UNITED STATES PATENT AND TRADEMARK OFFICE

10/598,782

| Office Action Summary | Application No. 10/598,782 | Applicant(s) PARK ET AL. | |

DETAILED ACTION

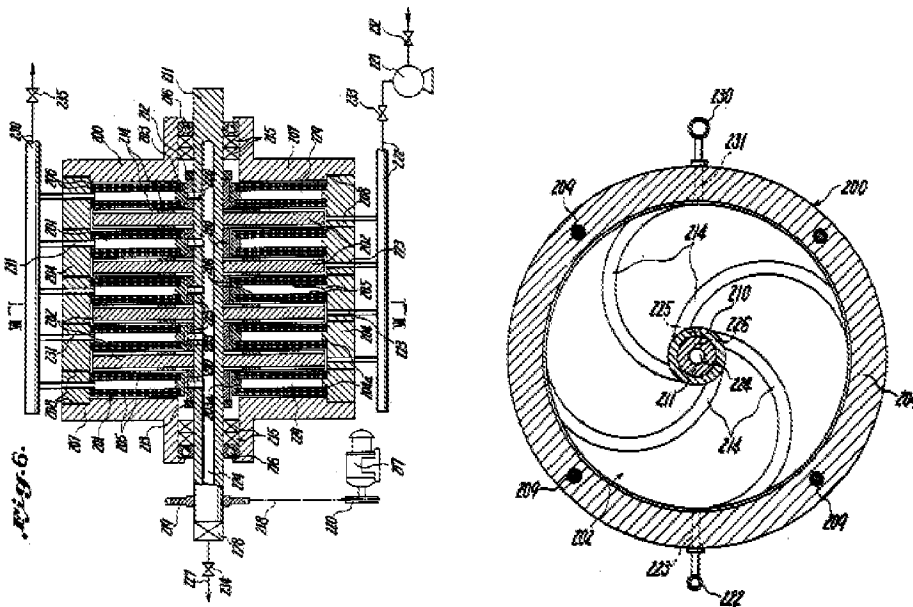
Sasaki teaches filter discs alternately interspersed with rotor discs as claimed – see figures 6 and 7 copied below. The rotor discs have vanes, ribs or ridges (214) on it.

The rotor discs differ from the “blades” as recited in applicant's claims in the light of the disclosure in the specification. However, “vanes” is only an obvious variation of the disc design, and is also known in the art as shown by Henttonen.

These references also differ from the specific claim limitation of “different positions” for the alternating blades. However, having the blades of Henttonen or the vanes of Sasaki being oriented in different positions would not be a patentable limitation because the blades or vanes could have differing positions as they are assembled as a random variable, and the teaching of the references do not specify that they have to be in the same position.
